1963 - 1964 Corvette: Service Bulletin: 3-Speed Transmission Problems

Source: Chevrolet Technical Service Bulletin

Bulletin No: TSB #1008 DR #676

Date: July 16, 1964

FIGURE 2 - MAST JACKET ASSEMBLY

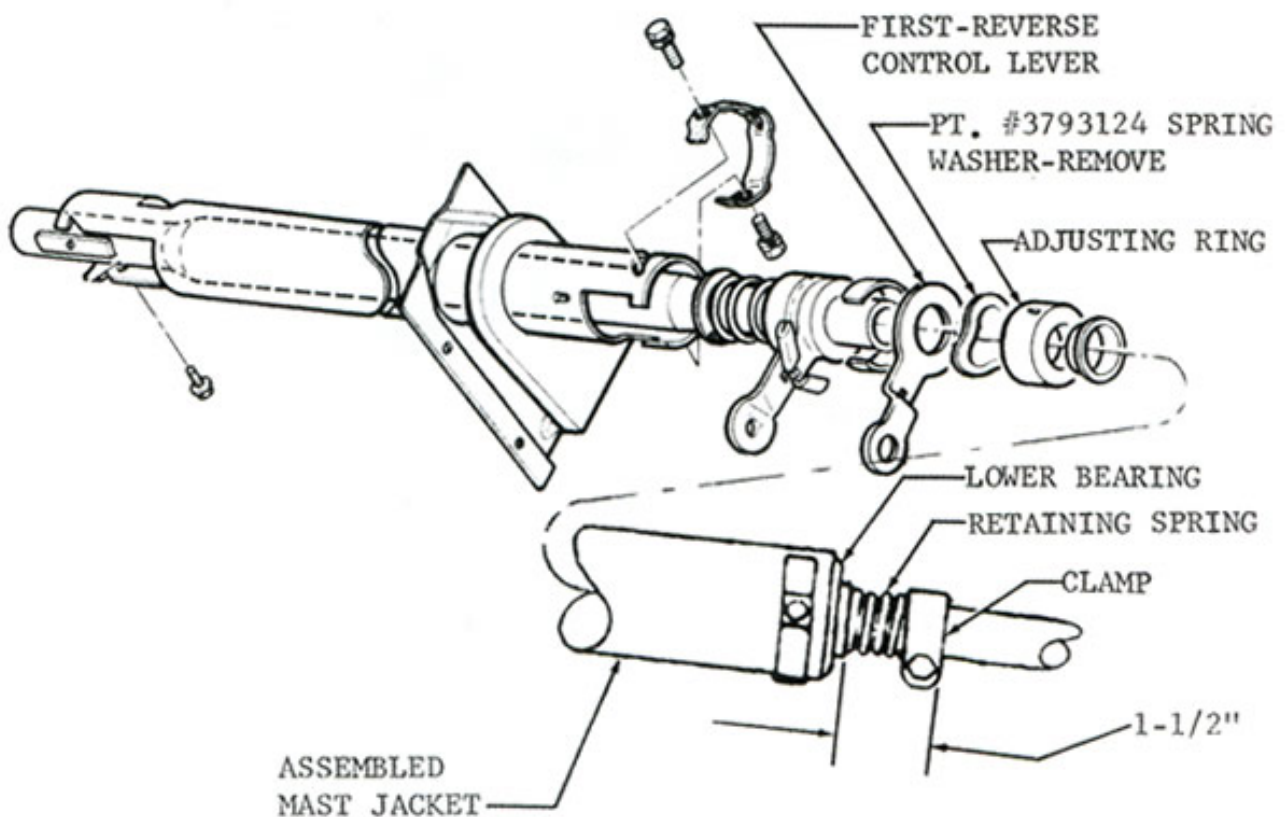
To provide a more positive shift on truck models, Part No. 3793124, transmission control 1st and reverse lever spring washer is being omitted in production and should be removed from units in service. The procedure to remove this spring washer and to readjust lever clearance is as follows:

1. Refer to Figure 2 for parts identification. Place shift lever in neutral; remove access cover from fender skirt.

2. Remove cap screws retaining adjusting ring to mast jacket.
3. Loosen steering shaft lower bearing retaining spring clamp.
4. Slide adjusting ring downward along steering shaft until Part No. 3793124, spring washer, is exposed. Cut and remove spring washer from steering shaft.
5. Apply lubriplate to thrust surfaces of control levers, relay lever and adjusting ring.
6. Position adjusting ring in mast jacket; align holes in ring with slots in mast jacket and install cap screws, but do not tighten.
7. Rotate adjusting ring upward until clearance of .005" exists between first-reverse control lever and ring as shown in Figure 3. Tighten cap screws.

8. Force lower bearing retaining spring clamp upward against spring tension until a dimension of 1-1/2" exists between lower bearing and clamp as shown in Figure 2. Tighten clamp bolt.
9. With transmission side cover selector levers in neutral position, adjust selector rod lengths per instructions in the appropriate shop manual to provide proper neutral cross-over. Replace access cover when adjustments are completed.

FIGURE 4 - INSTALLATION OF THRUST WASHERS IN CHEVY VAN

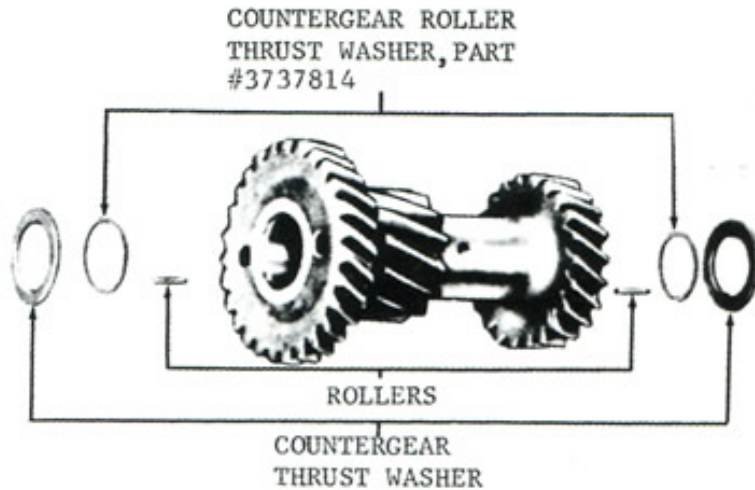
On Chevy Van models with three-speed transmissions, a small steel thrust washer is used between the countergear thrust washer and the countergear roller bearings at each end of the countergear. Since the 1964 Chevy Van Shop Manual is supplemented to the 1963 Truck Shop Manual in this area, reference to this part is omitted in error.

Figure 4 illustrates installed location of this thrust washer in Chevy Van transmissions.

FIGURE 5 - INSTALLATION OF MAGNETIC CHIP COLLECTOR

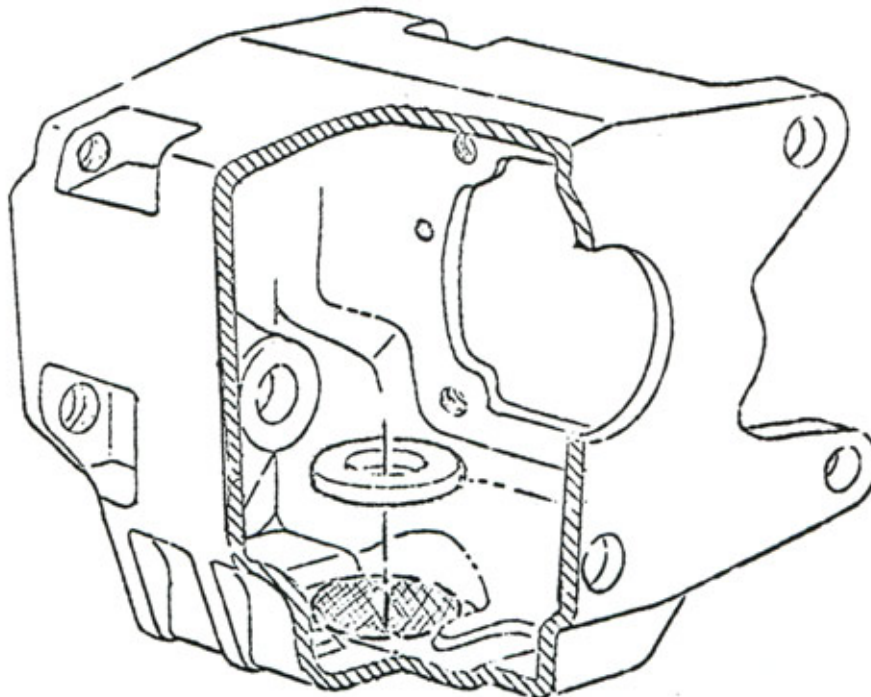
To reduce bearing noise and increase bearing durability, two changes have been released for production. First is the installation of a magnetic chip collector which went into effect on June 5, 1964. Second is the use of a new clutch gear and mainshaft bearing that incorporates a slinger ring on the inner race. This change went into effect on transmissions for use on 327 cu. in. engines on June 11, 1964, and is estimated to go into effect the week of June 22, 1964, on remaining transmissions.

Service Kit #3869240 has been released for field installation of the chip collector on 1963 and 1964 3-speed transmissions built prior to the above dates. The kit includes the magnet, cement, and instruction sheet. It also contains a 3/8 inch high pedal bumper for increasing clutch release on all except Chevy Van (Reference - Gear Clash - First and Reverse Shift). It is recommended that whenever a 1963 or 1964 3-speed transmission is disassembled for any reason, that the magnet be installed using the following procedure.

3. Wipe magnet and area in case where magnet is to be installed with Acetone or Toluol (available at most drugstores). Area where magnet is to be installed must be clean, dry and free from oil and grease film. When Acetone or Toluol is applied, be sure to use in ample quantity to neutralize grease and oil which may be in pores of casting surface. Do not touch cleaned area with hands.

4. Using cement supplied in kit, apply about a 1/16 inch thick film over entire bottom surface of magnet and immediately place in case as shown in sketch. Press straight down - do not twist while pressing in position. Note: If cement from tube appears to be thick, discard thick or hardened chunks and use cement from middle or bottom of tube.

5. To cure cement, place a trouble light with a 100 watt lamp inside of case as close to magnet as possible, and allow to stand for a minimum of 30 minutes. Use care not to touch magnet or knock it out of position. A heat lamp, if available, may be used in place of 100 watt lamp.
